ADDENDUM NUMBER 1

Issued: April 5, 2016

North Bay Water Reuse Program Sonoma Valley County Sanitation District
Fifth Street East Recycled Water Pipeline

TRENCH SURFACE TYPE 1
(WATMAUGH RD)

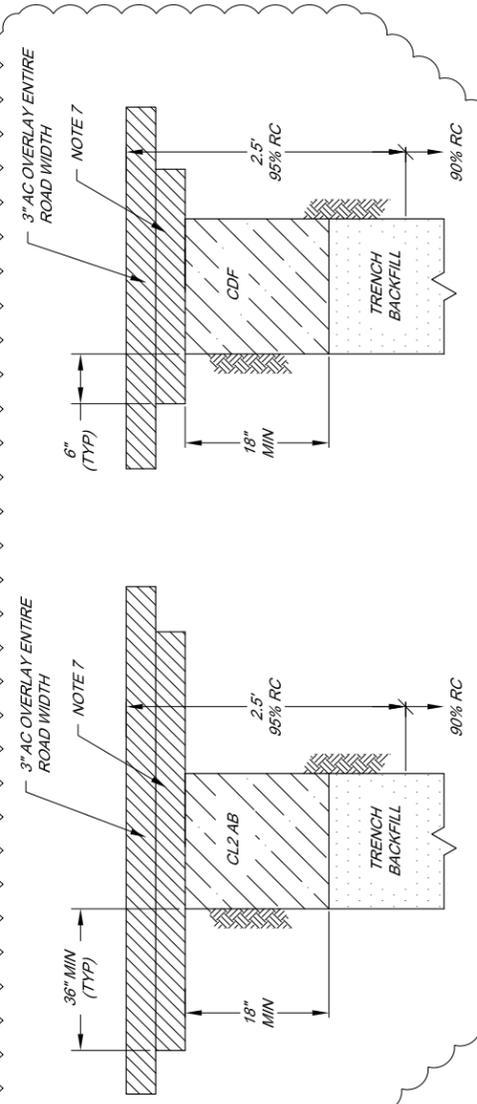
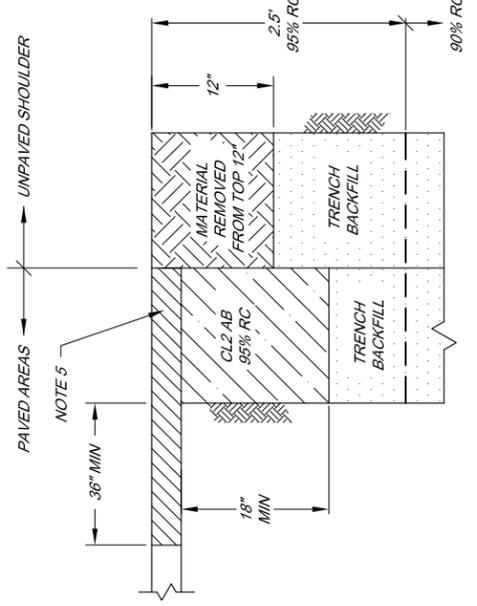
- C. Sheet D-3 detail for Type 1 Trench Surface indicates matching the existing pavement 36-inch from the trench edge, but is only shown on one side of the trench. What is the intent of this detail, and should we assume the pavement extends 36-inches on both sides?

- IF SOFT MATERIALS ARE PRESENT IN TRENCH BOTTOM, PROVIDE DRAIN ROCK AS DIRECTED BY OWNER.
- REMOVE AND REPLACE THE EXISTING ASPHALT CONCRETE PAVEMENT TO THE NEAREST LANE LINE. WHERE EVER THE 3-FOOT "T" CUT CROSSES THE CENTERLINE STRIPE, FULL-WIDTH PAVING IS REQUIRED. REFER TO COUNTY OF SONOMA DEPARTMENT OF TRANSPORTATION AND PUBLIC WORKS DRAWING 219 FOR ADDITIONAL DETAILS.

- AC TRENCH SURFACE SHALL BE 3" IN THICKNESS.

FIFTH STREET EAST RECYCLED WATER PIPELINE
TRENCH DETAILS
DRAWING NUMBER: D-3
SHEET 21 OF 23

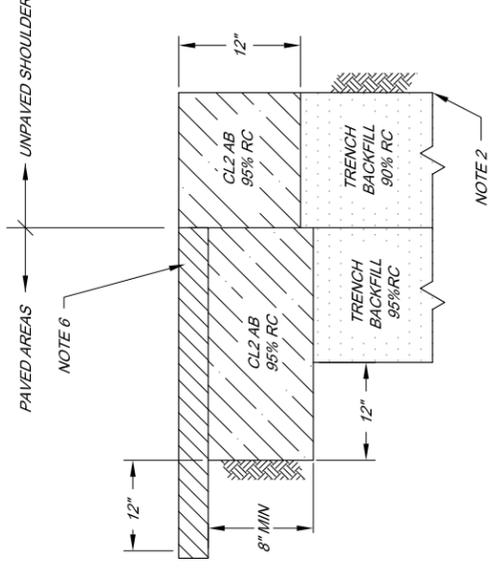
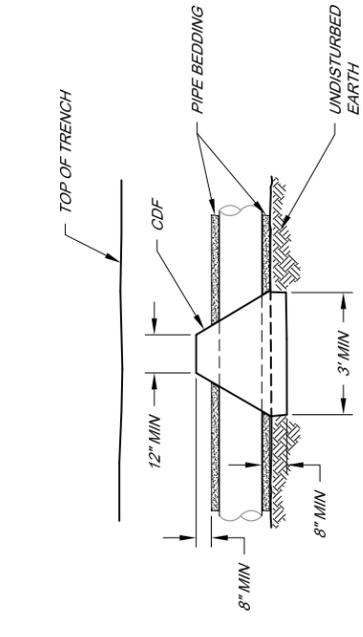
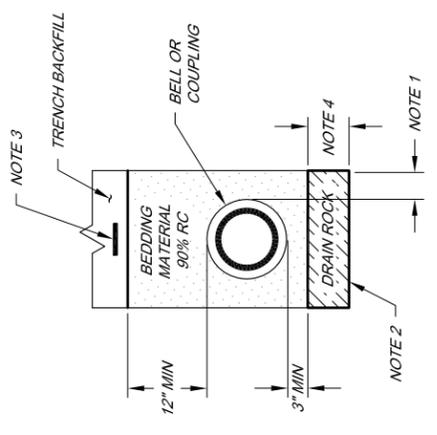
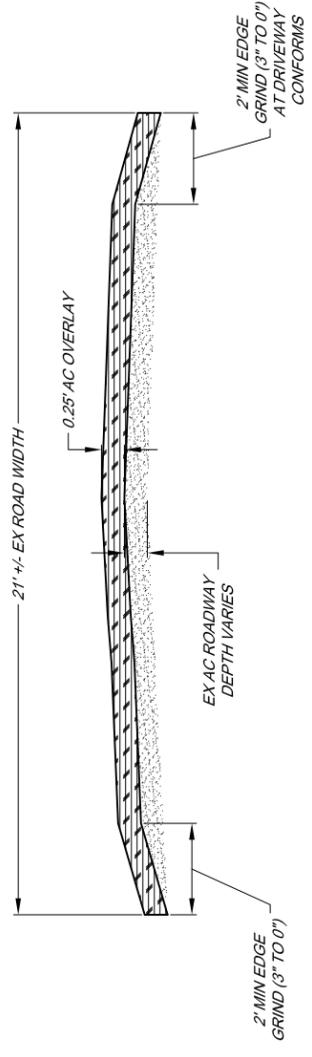
- A. Delete Drawing No. D-3 and replace with revised Drawing No. D-3 attached and marked "04-05-16 Addendum No. 1"
-

- A. Bid Item #24 description indicates providing a 2-inch thick asphalt overlay, however, the overlay details on sheet D-3 indicate a 3-inch overlay. Please clarify the overlay thickness.

- D. Sheet D-3, Note 6 and Note 7 both indicate to install 0.25' (3") min AC or match existing (whichever is greater). When open ended notes such as this are included in plan sets the contractor is usually given some geotechnical information such as borings to derive reasonable bid assumptions on the thickness of the existing asphalt. For this job the Geotechnical analysis only includes two bore holes that were taken outside of the pavement. We cannot reasonably perform investigations to determine the depth of existing asphalt along the entire pipe alignment. It would seem that the County Detail using 0.35' thick on the Type 2 Trench Surface would be reasonable at all locations. To provide competitive and comparable bids (and as a matter of fairness), can we be provided with the depth of pavement for use in bidding?

24. Roadway Resurfacing – Type 1 (Watmaugh Rd). The unit price paid under this item shall be full payment for cleaning of street; tack coat; and providing a ~~2~~3-inch thick asphalt overlay as indicated. For purposes of payment, this item will be paid by the square yard of asphalt concrete overlay placed.

- FIFTH ST EAST = 0.35'
NAPA ROAD CROSSING = 0.45'
SAWCUT EXISTING PAVEMENT 24" MIN. BEYOND EACH SIDE OF TRENCH. PROVIDE 0.25' MIN AC OR MATCH EXISTING AC (WHICHEVER IS GREATER).
